July 25, 2017
Medway Planning and Economic Development Board
155 Village Street
Medway, MA 02053

Public Hearing Continuation - O'Brien and Sons - Site Plan and Groundwater Protection Special Permit:

Re: Bottle Cap Lot, LLC (O'Brien & Sons Corporate Office)
17 Trotter Drive, Medway, Massachusetts
Revised Layout Summary
MAI Project No. 8477

LAYOUT & MATERIALS PLAN
O'BRIEN & SONS CORPORATE OFFICES

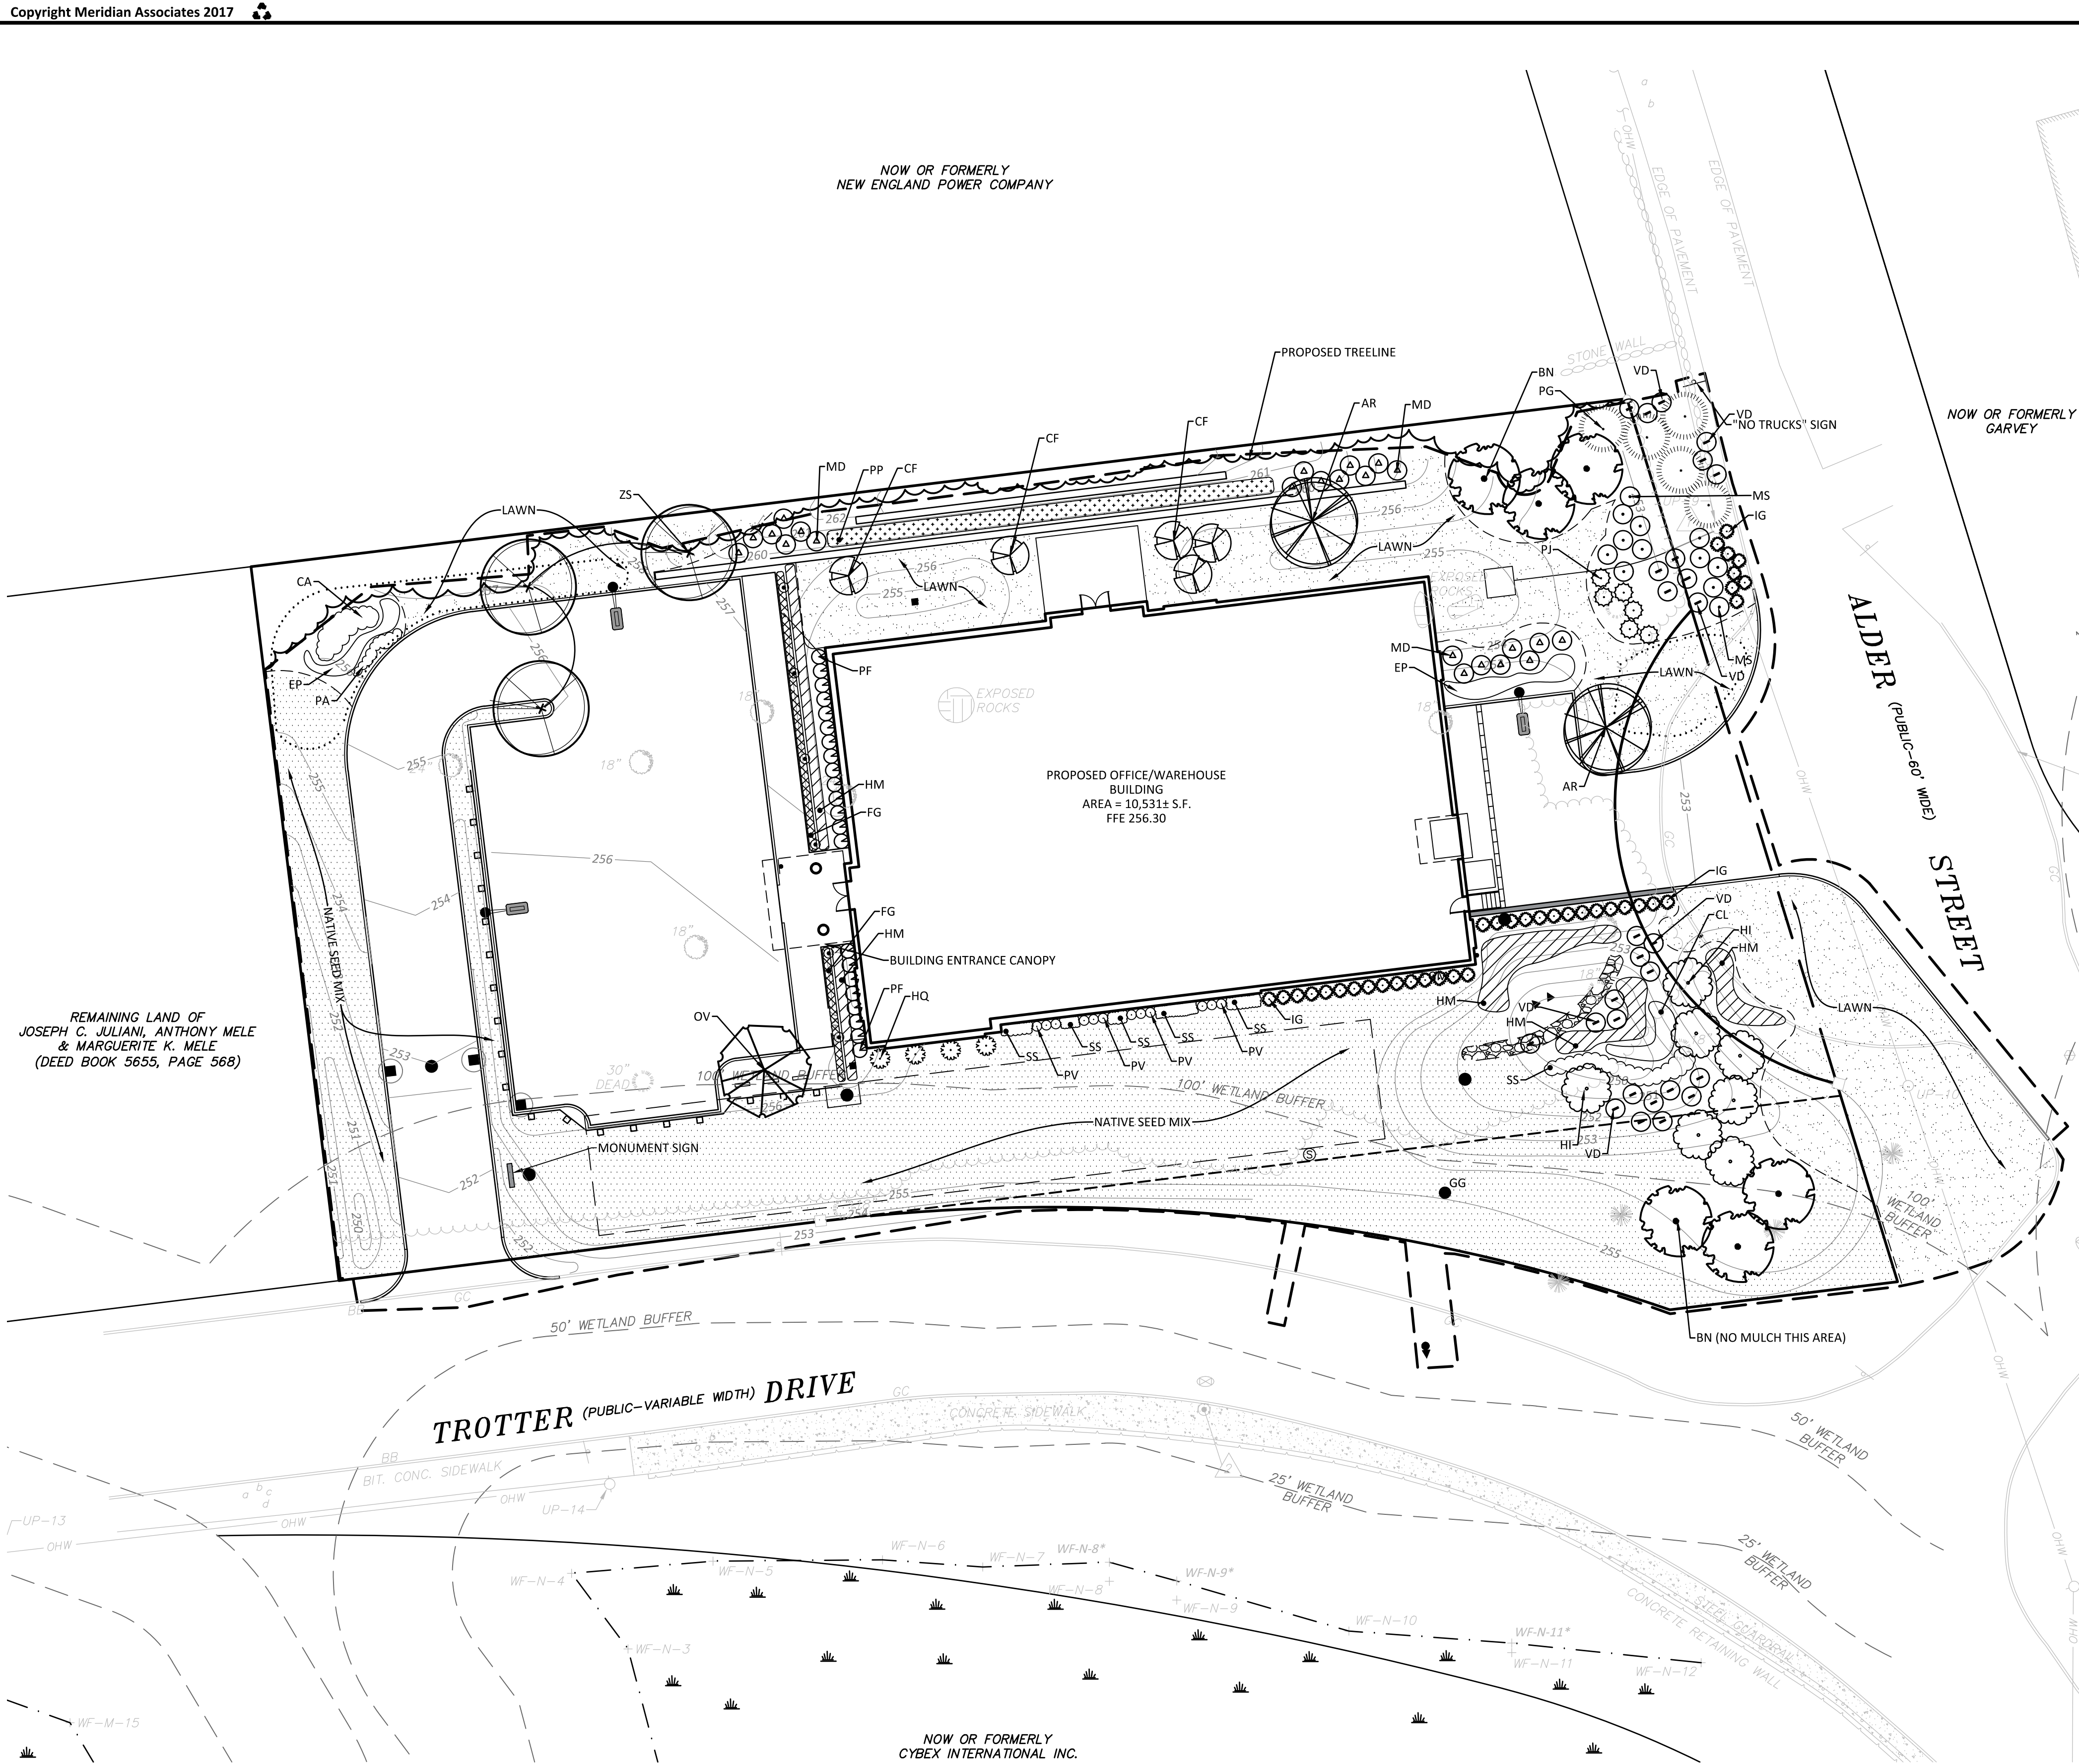
- 6) The plans do not show proposed curb radii or traffic pattern markings for parking areas. (Ch. 200 §204-5.D.2)
- *MAI 6/13/17 Response: Proposed curb radii and traffic pattern markings, where appropriate, will be added to the Layout & Materials Plan (sheet C-2)*

- MAI 6/13/17 Response: *Proposed curb radii and traffic pattern markings, where appropriate, will be added to the Layout & Materials Plan (sheet C-2)*

- TT 7/6/17 Update: TT has not received an updated Plans set. We will comment further as plans are provided.
 - *MAI 7/18/17 Response: Proposed curb radii have been added to the Layout & Materials Plan (sheet C-2). Traffic pattern markings were found not to be necessary.*

- TT 7/6/17 Update: TT has not received an updated Plans set. We will comment further as plans are provided.
 - MAI 7/18/17 Response: *Proposed curb radii have been added to the Layout & Materials Plan (Sheet C-2). Traffic pattern markings were found not to be necessary.*

- *MAI 7/18/17 Response: Sight distances at the proposed driveway on Trotter Drive have been added to the Layout & Materials Plan (Sheet C-2)*
 - TT 7/21/17 Update: This item has been addressed to our satisfaction.

Figure No.

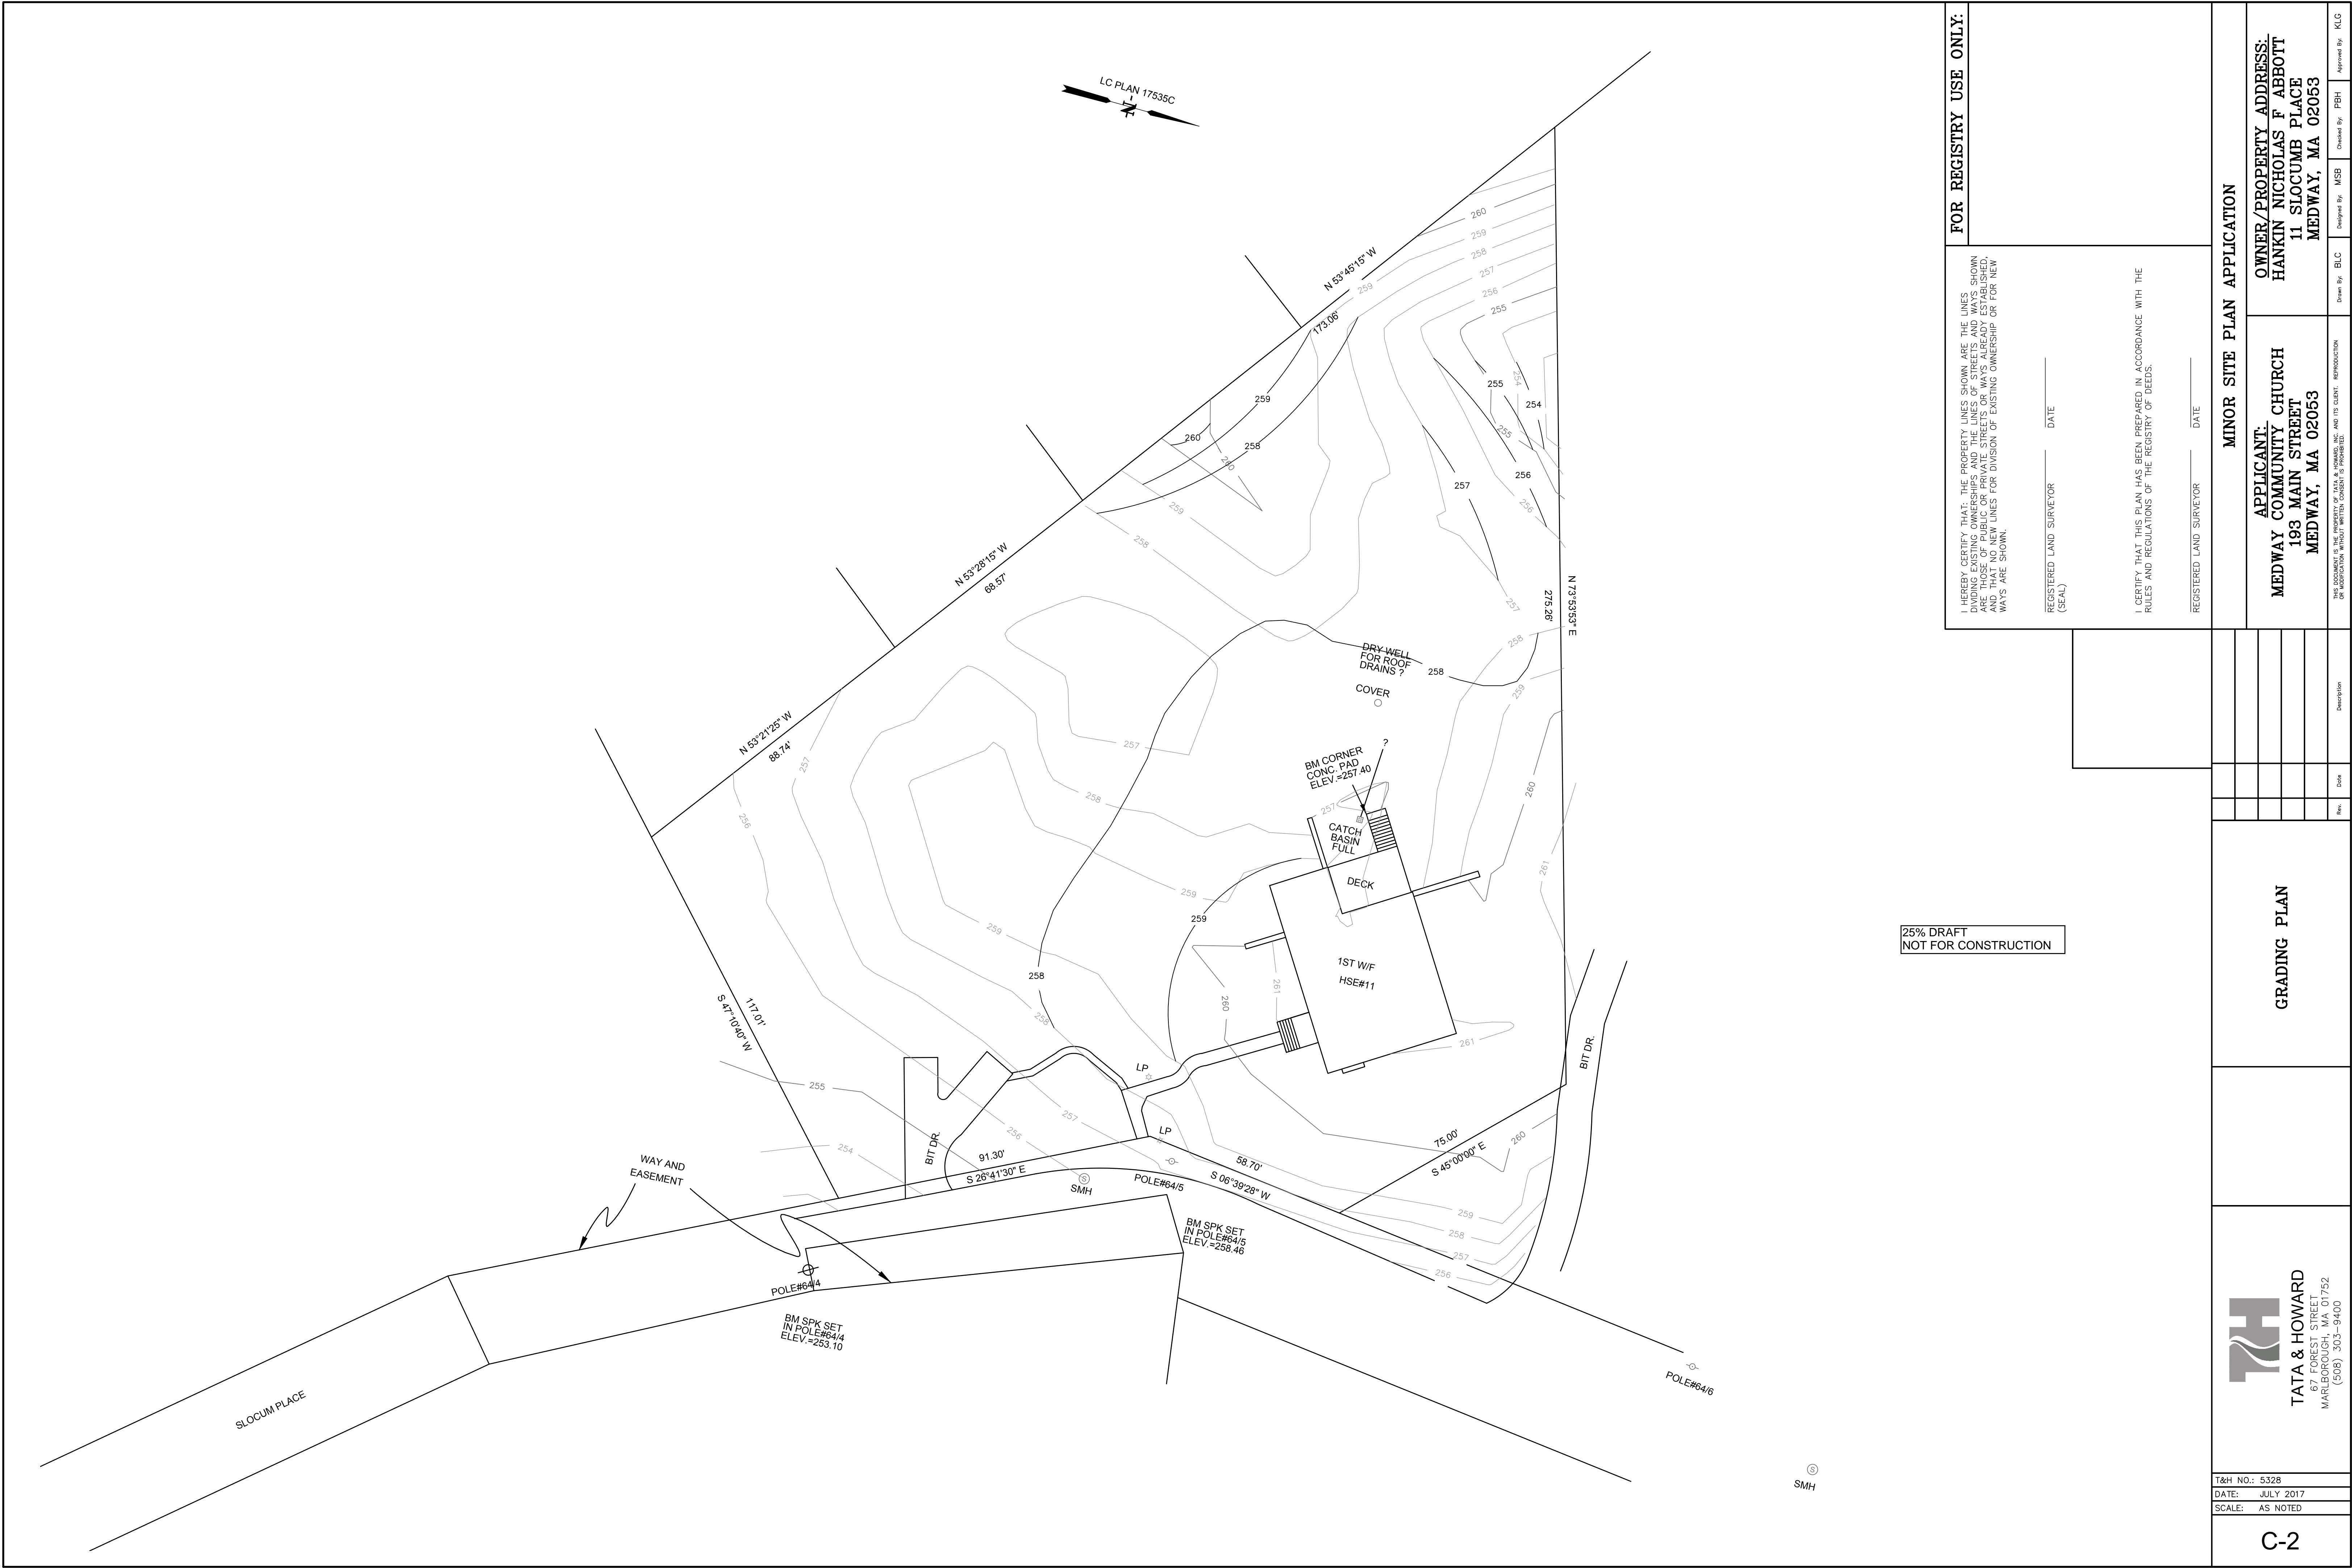
The parking plan was shown. The Board advised that the Fire chief will need to provide his review and recommendations. The church would like the road to be 24 ft. wide with 12 ft. in and 12 ft. out lanes. They will use bump stops to delineating the parking spaces.

Consultant Bouley recommended that they change this to one way traffic flow. This would require a reduced driveway width and allow for a bigger buffer area with abutters. This would also help with drainage.
